Replacement Water Pump Kit and Replacement Fan Clutch Kit

for Groundsmaster 4000 Series Traction Unit

Installation Instructions

Figure 1

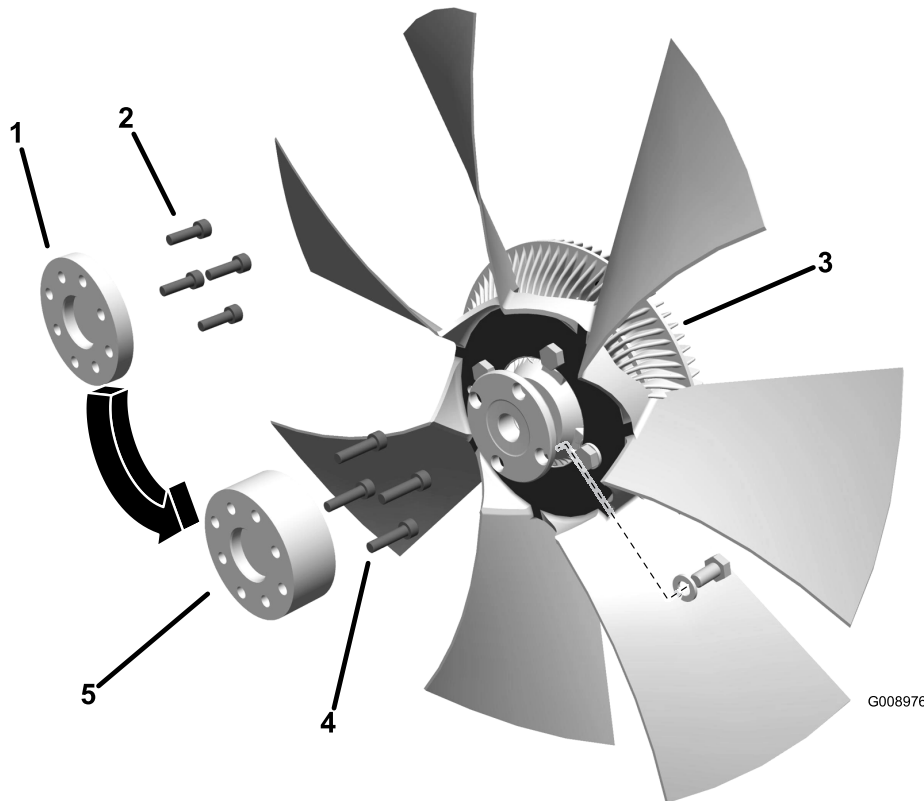
This kit is a supplement to the water pump replacement kit and the fan clutch replacement kit. It includes an update spacer that is shorter than the existing spacer on the machine and new, shorter cap screws. A table

below describes when the new spacer and shorter cap screws should be used when replacing the water pump or fan clutch.

For:	Use:
GM4500 & GM4700	Remove and discard the existing 1.06" long fan spacer (105-4509) and four existing cap screws (48-7850). Install the new .50 inch long fan spacer (100-3066) and four new shorter cap screws (52-6290).
GM4000 & GM4100 <i>without</i> the optional air conditioning kit	The supplied new .50 inch long fan spacer (100-3066) and four new cap screws (52-6290) are the same spacer and cap screws that are currently installed on the machine, replacement is not necessary.
GM4000 & GM4100 <i>with</i> the optional air conditioning kit	DO NOT install the new .50 inch long fan spacer (100-3066) and four new cap screws (52-6290). Use the existing 1.06" long fan spacer (105-4509) and four existing longer cap screws (48-7850).
